## **1<sup>st</sup> Ordinary Council Meeting**

**Tuesday, 15 November 2016  
5.00pm**

#### 13.1 Esplanade Cycle Lane Common No. 2661536

The purpose of this report is to refer to Council for comment, Pursuant to Section 48 of the *Planning Act*, the following development application: Lot 10563 (91) Woods Street, Darwin - 21 storey building comprising 48 x 2 and 63 x 3 bedroom multiple dwellings with ground level commercial tenancies and four levels of above ground car parking - PA2016/0593.

3361 - SK 201 H

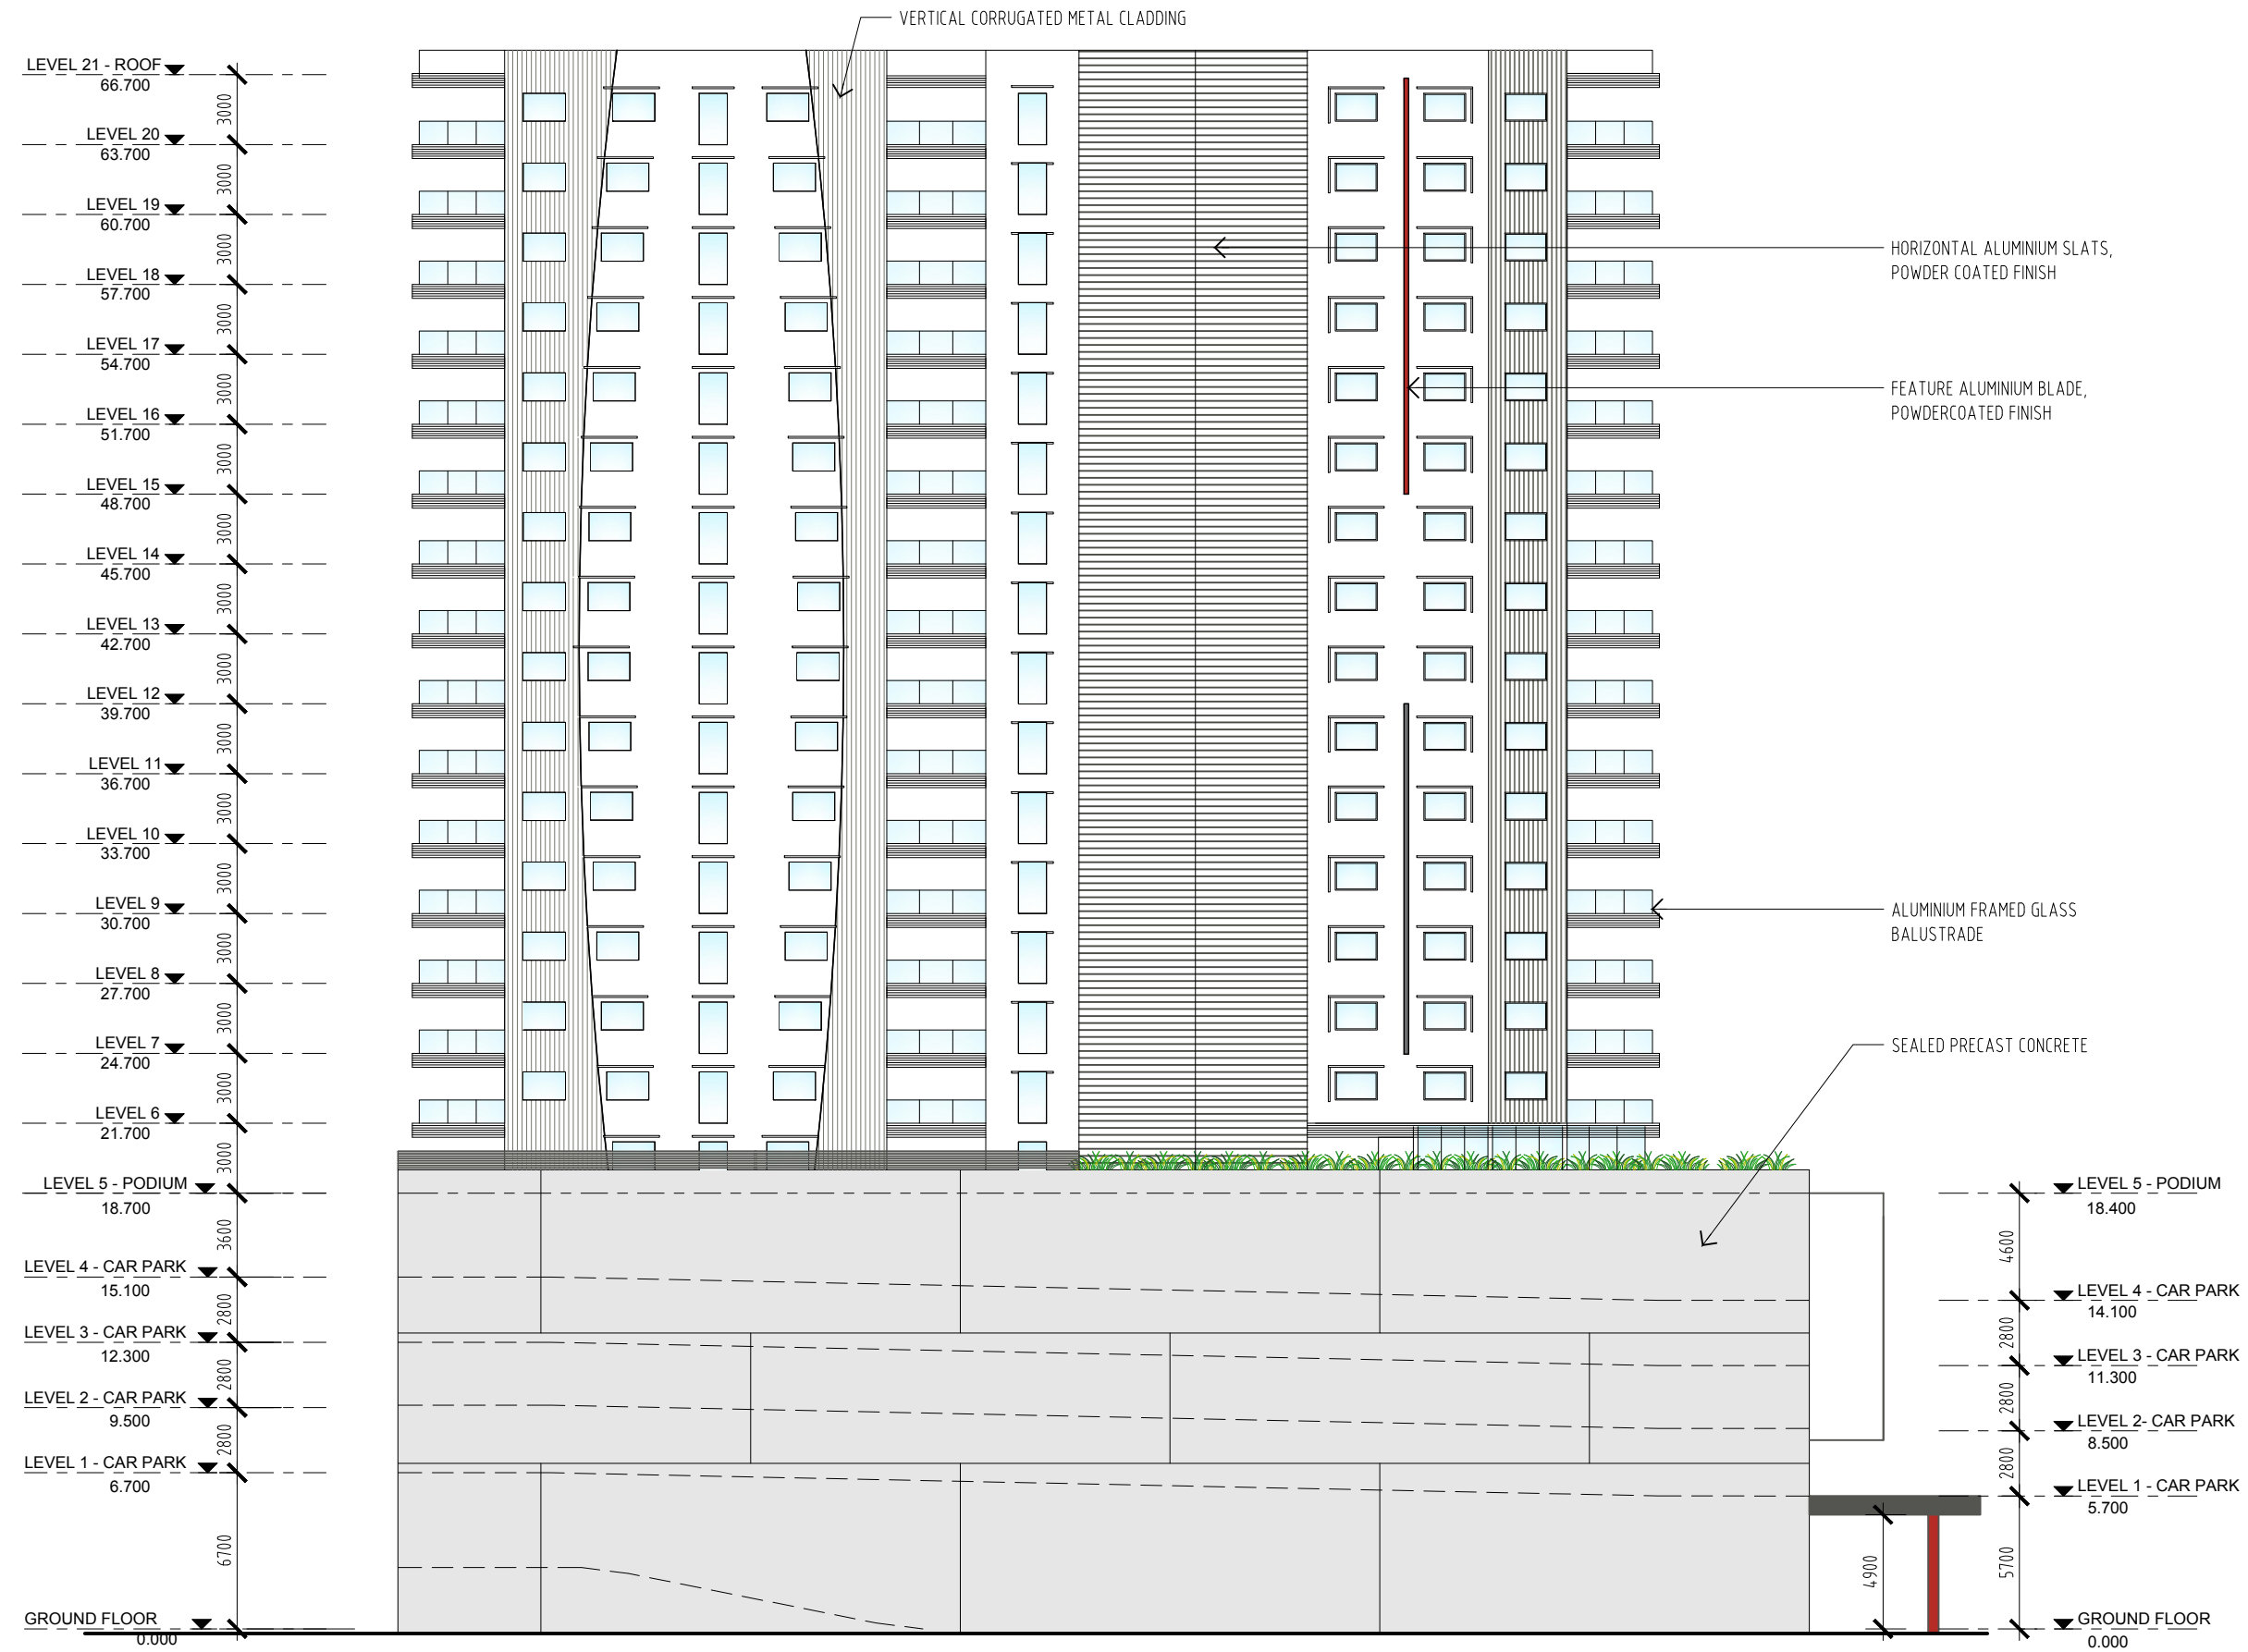
Clauses 7.8 and 8.2 of the Scheme requires the design of buildings to minimise expanses of blank walls. It is considered that the treatment of the proposed south-east and north-west elevations at tier one should be enhanced to contribute to the amenity of the surrounding area; particularly given that the surrounding area is currently underdeveloped. Approval of the blank walls to a height of approximately 19m would provide a poor urban outcome and treatments should be included to achieve an attractive and pleasant development.
